1.6 DA Scheduling, Congestion Management and Re-dispatch (Balanced Submissions) Beginning state.

Example

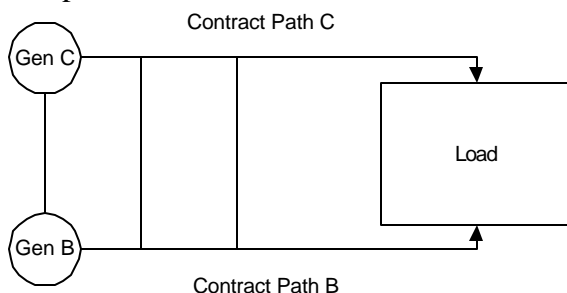
Clarification needed on how curtailment and re-dispatch would work

Using the simplified example above, if Contract Path C goes out of service should;

1. Generator C only be reduced (Contract Path method used today).
2. Generators B and C be reduced based on actual flow.
